# Access Compliance Report

## Public Rights-of-Way

Intersection ID: 51340	Main Street: MARK_PL	Cross Street: FIELDSTONE_MANOR_DR	Location:	N
ADA ID: A7BAC56FB5DF	Ramp Type: PerpDiag	Initial Pass/Fail: Fail	Overall Compliance: No	Severity Score: 10

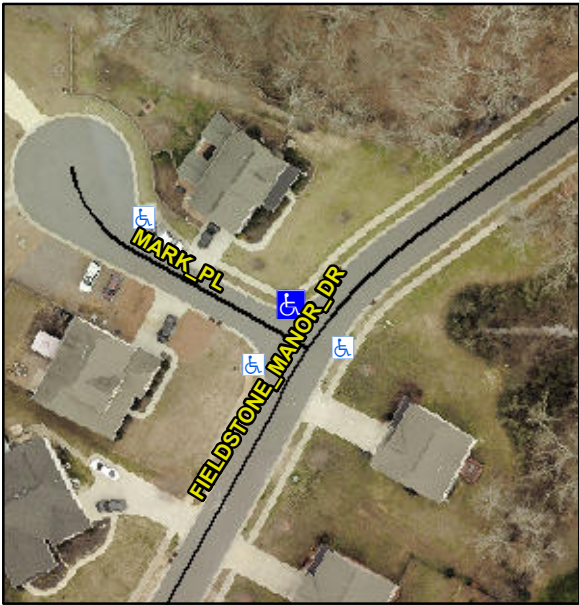
Codes/Mitigation Info/Possible Solution			Field Measurements/Component Compliance						
	Possible Solutions:		<b>Remove &amp; Replace Curb Ramp With Two New Directional Ramps or Equivalent.</b>						
	Surveyor Notes:		<b>N/A</b>						
	PROW/ADA:		<b>R304.5.1, R304.5.3</b>						
	Street 1 Name		<b>MARK PL</b>						
	Stop Condition-Street 2		<b>StopSign</b>						
	Street 2 Name		<b>FIELDSTONE MANOR DR</b>						
	Stop Condition-Street 1		<b>None</b>						
	Total Cost:		\$ 3200.00
